MICROLIGHT AIRWORTHINESS APPROVAL NOTE

MAAN NO:1744

TITLE: Microlight Airworthiness Approval Note 1744, Sky Ranger - Service Bulletins 001 and 002.

Applicability: All Sky Ranger aircraft

Figure 1; diagonal seat brace.

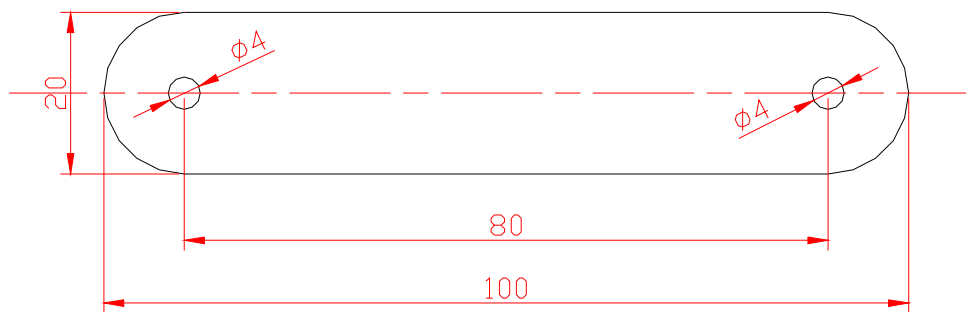
The seat base webbing on some Skyranger aircraft is sufficiently slack to allow the square seat base to deform and slip off the rear supports during periods of negative-g loading. This presents a risk of fouling the port rudder cable which runs under the pilot's seat. To prevent this occurring diagonal braces must be fitted to the seat bases.

The diagonal braces should be made from 1.5mm thick aluminium sheet or strip, 20mm wide by 100mm long, Figure 1. Two 4mm holes should be drilled in each brace at 80mm centres.

Figure 2; seat base diagonal brace in situ.

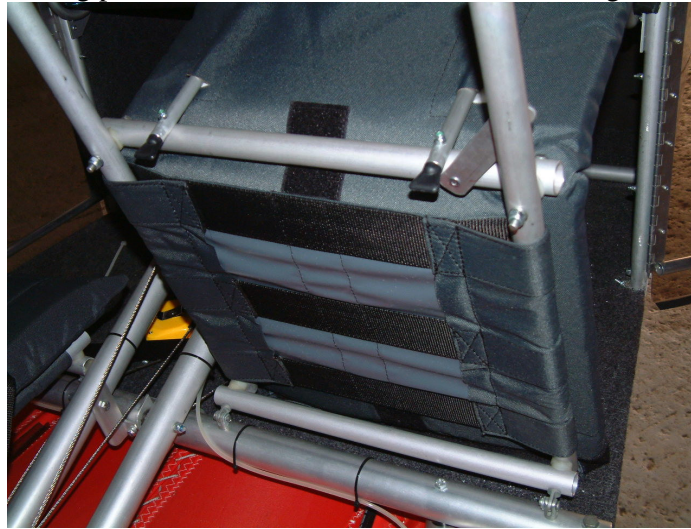
A small diagonal bracing piece should be fitted to each seat base, Figure 2.

One brace should be fitted to each seat, between the top surface of the outboard seat base tube and the undersurface of the seat base rear tube as shown in Figure 2. The brace should be at approximately 45° to the two tubes to which it attaches. Mark the position of the brace on the seat base rear tube, and drill and rivet in place with a 4mm steel rivet. Then, with the seat in position on its supports, mark and drill the other hole to accurately hold the correct position, and secure with another 4mm steel rivet.

Figure 3; stainless steel plates.

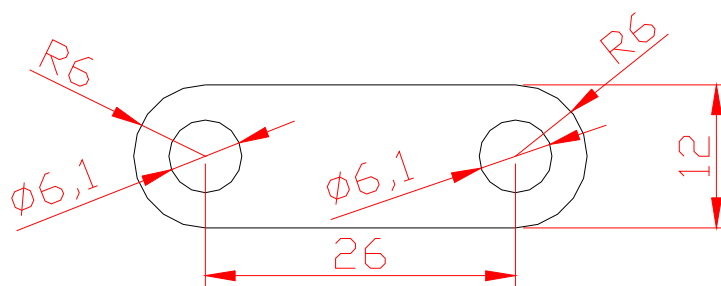
In order to further increase the level of safety when rigging and de-rigging the Skyranger a modification to the aileron cable connections at the control stick has been designed. This makes it difficult to miss-rig the ailerons by handing the cable connections.

Stainless steel plates, 4 off; the plates should be made from 1.5mm thick stainless steel sheet or strip as per Figure 3.
